Section 2.5 – Geology, Seismology, and Geotechnical Engineering

(Applies to RAIs 2.5-1 through 4)

Figure 2.5-5-1: Composite Aeromagnetic Anomalies and Main Geological Structures, Southern Wisconsin

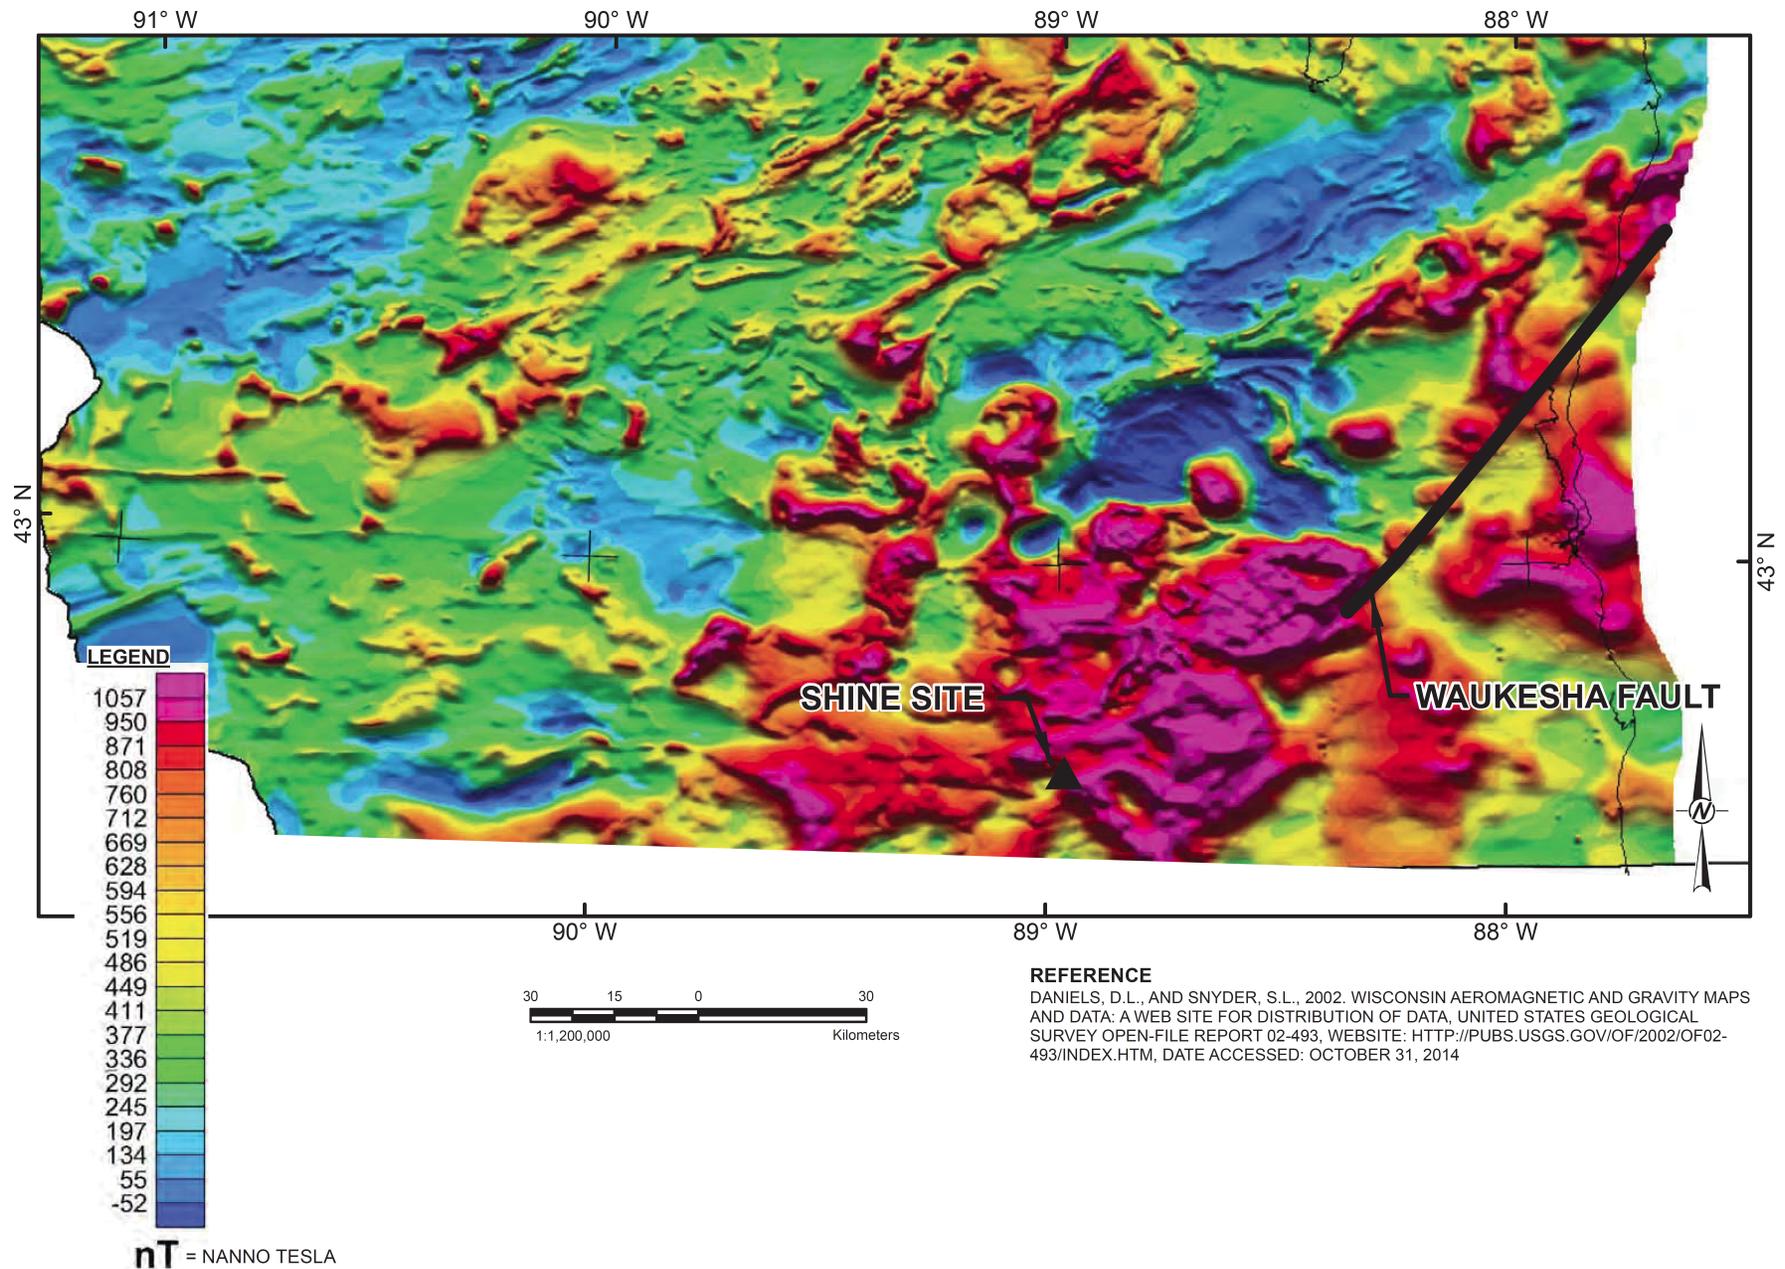
Provide additional information expanding the discussion of regional magnetic and gravity geophysical anomalies presented in SHINE PSAR, Section 2.5.1.5, "Regional Magnetic and Gravity Geophysical Anomalies," to include an evaluation of potential karst features at the SHINE site.

Details of the composite aeromagnetic and Bouguer gravity anomalies in southern Wisconsin are provided in Figure 2.5-5-1 and Figure 2.5-5-2, respectively, to expand the discussion of regional geophysical anomalies and to include an evaluation of potential karst features at the SHINE site.

The major structure observed from the geophysical anomalies provided in Figure 2.5-5-1 and Figure 2.5-5-2 is the northeast-striking Waukesha fault, identified from structural contours of the Precambrian basement rocks. Structural contours indicate up to 1500 ft of vertical separation across the Waukesha fault. Based on three-dimensional modeling of aeromagnetic and gravity anomalies, a total vertical separation of approximately 500 to 1100 meters at the Waukesha fault is inferred (Reference 13).

- Smaller faults and folds within the Paleozoic Era are not resolvable in the aeromagnetic anomaly map (Figure 2.5-5-1).
- The offset across the basement rocks at the Waukesha fault can reasonably be resolved in the Bouguer gravity anomaly map (Figure 2.5-5-2).
- Smaller faults and folds within both the basement and bedrock rocks are not readily apparent in the Bouguer gravity anomaly map (Figure 2.5-5-2).
